ATTACHMENT A

BEAVER VALLEY - UNIT 1

Proposed Change Request No. 86 amends the Beaver Valley Power Station, Unit No. 1 Technical Specifications, Appendix A concerning various administrative changes.

Figure 6.2-1
Offsite Organization (Partial)

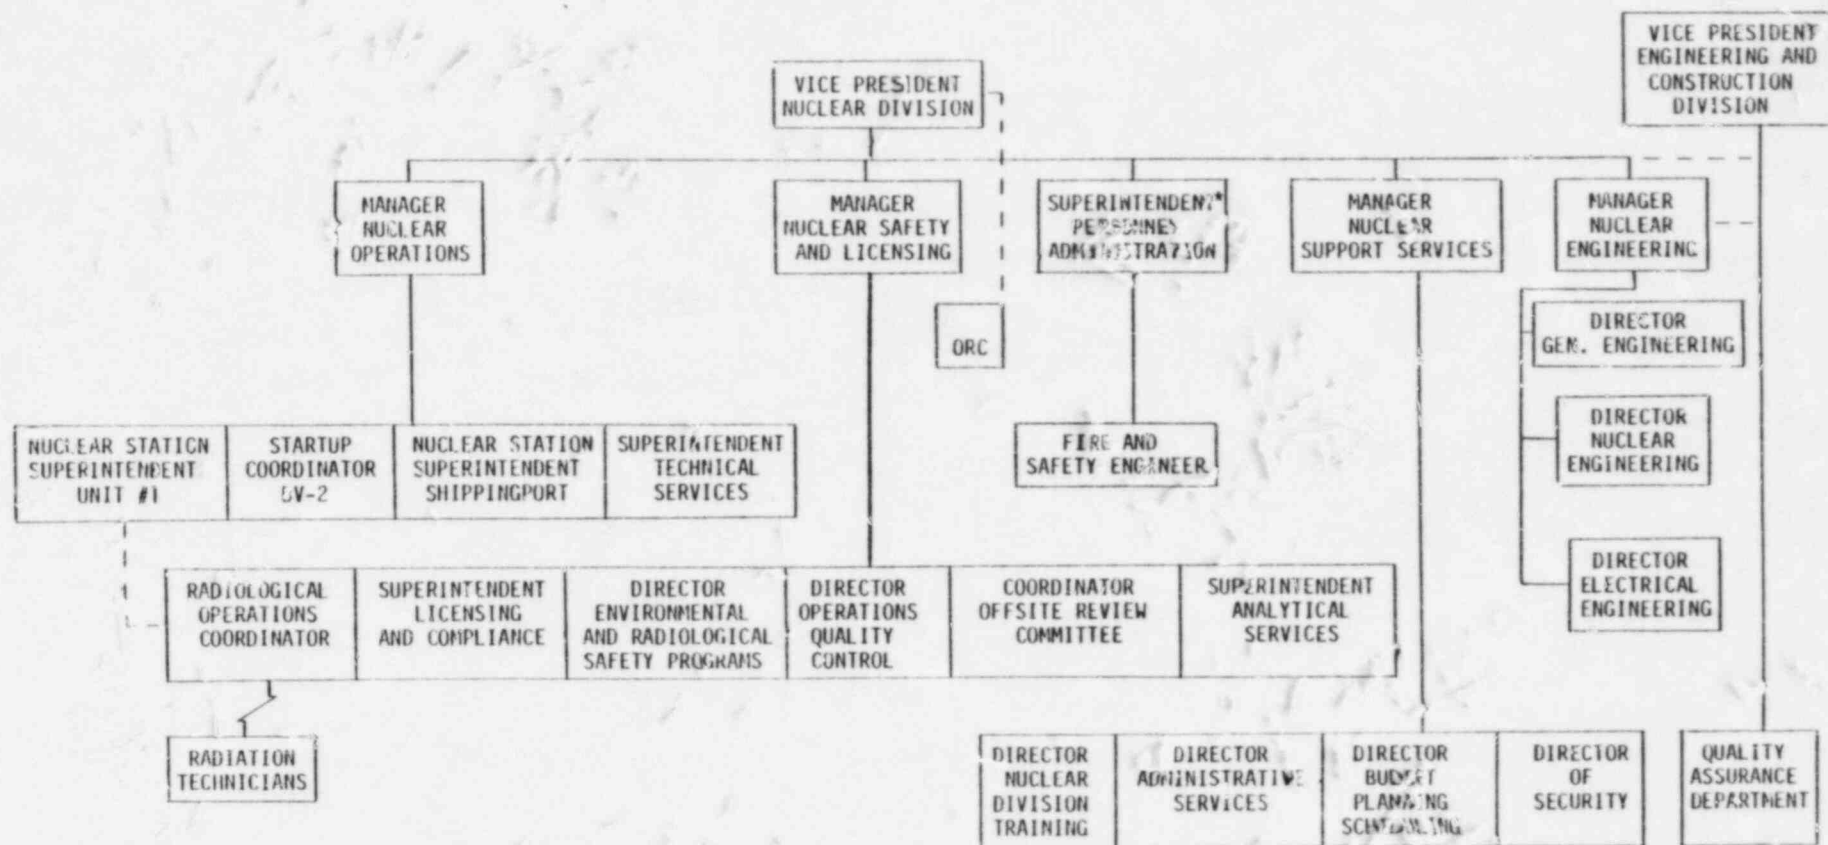
4. Section 3.6.1.1 - Containment Systems, has been revised to correct a typographical error.
5. The offsite organization, Figure 6.2-1, has been revised to update the title from Director to Superintendent, Personnel Administration and to incorporate the organization under the Manager, Nuclear Engineering.

Figure 6.2-1, Offsite Organization, has been revised to reflect reorganization changes. This change is not a safety concern and does not affect the UFSAR.
